Track Standards Bulletin #008

August 30, 2022

Bulletin No. 008

Figure 19-A. Location of Permanent Transition Tie Sets

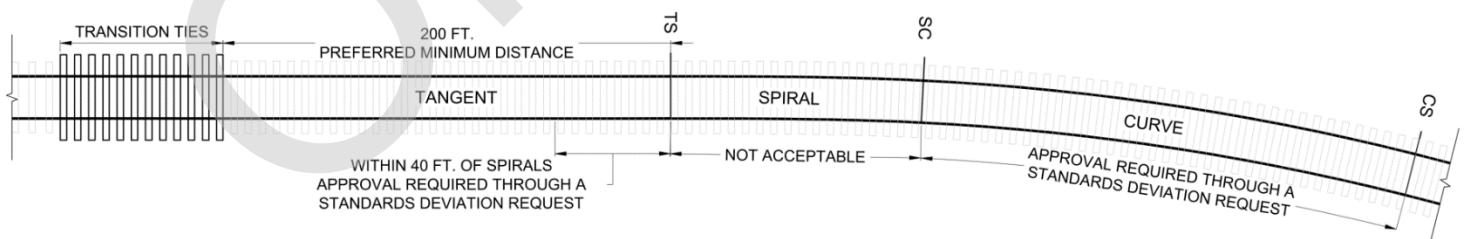
9. Permanent transition tie sets shall not be placed within horizontal curves nor within spirals. The distance between transition tie sets and spirals (TS and ST geometry points) and simple curves (BC and EC) shall be the greater of:

Preferred minimum: 200 ft. (61.0m)

Absolute minimum: 40 ft. (12.20m)

Any values lower than 200 ft. (61.0m) must be reviewed and approved by Engineering & Asset Management - Track.

Installation of permanent transition tie sets within 40 ft. of spirals or in full body of curves must be reviewed and approved in writing through a Standards Deviation Request.

Figure 38-A. Destressing Length for Open Cut Culvert Installations

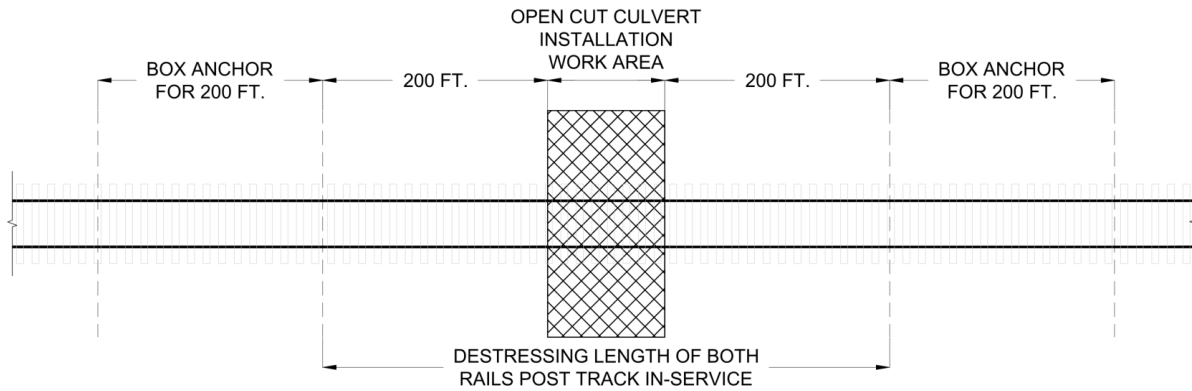
22. When open cut or excavation/tie removal culvert installation methods are leveraged on timber tie trackage, both rails must be box anchored (every tie) for 200' commencing 200' from the work area in each direction. Destressing of both rails must be conducted post Track In-Service. This distance of the destressing limits shall encompass the work area, plus 200' in both directions.

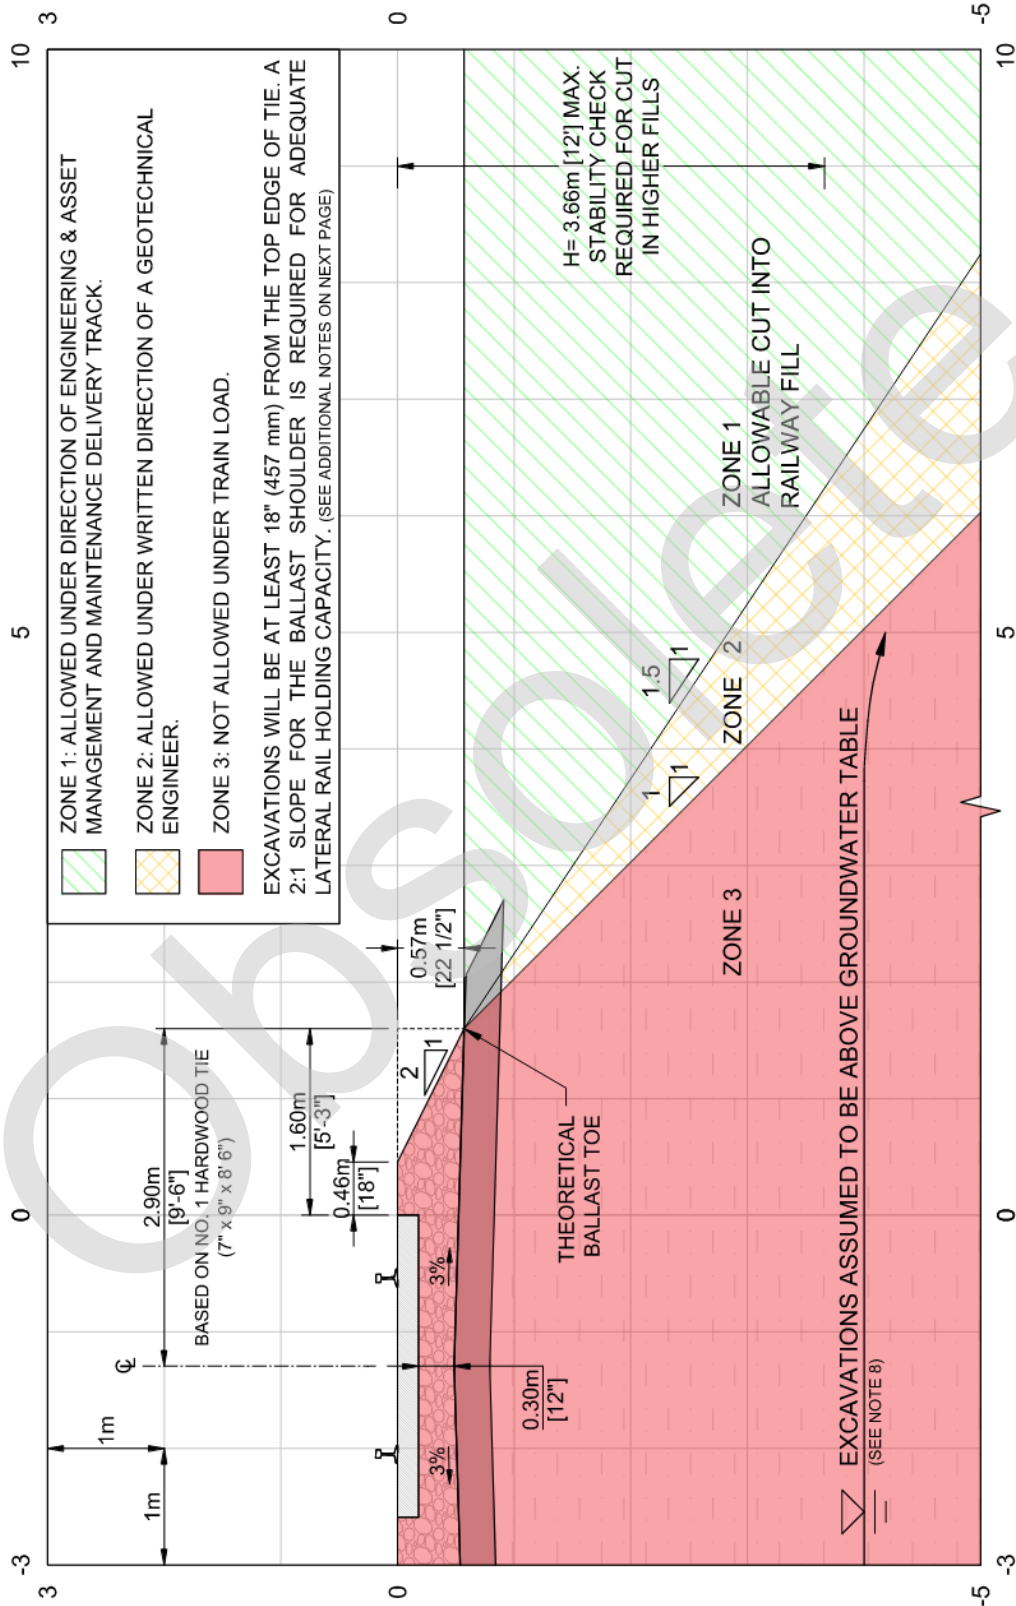
- c. Place MGPT between the rails so that shoes rest on the rail base.
WARNING: THE MGPT MAY BE DAMAGED IF NOT USED PROPERLY. DO NOT ATTEMPT TO USE MGPT ON ANY OTHER PART OF RAIL SURFACE.
- d. Measure and record the initial unloaded track gauge using tape measure or other measuring device.

- e. Apply hydraulic pressure by pumping the handle and load the track to 4000 lbs. (4000 psi on the gage). CAUTION: DO NOT EXCEED 4000psi. EXCESSIVE PRESSURE WILL DAMAGE THE MGPT AND MAY CAUSE PERSONAL INJURY.
- f. Measure and record the fully loaded track gauge using tape measure or other measuring device.
 - i. If the MGPT confirms that the defect exceeds the standard for the class of track, immediately apply the appropriate track protection if not already in place and repair the defect. If the defect cannot be immediately repaired, apply the appropriate slow order protection for which can accommodate the defect.
 - ii. If the MGPT confirms that the gauge measurement is acceptable for the class of track, the track protection can be released contingent on a repair plan submitted to Metrolinx.
- g. Release the hydraulic pressure on the MGPT
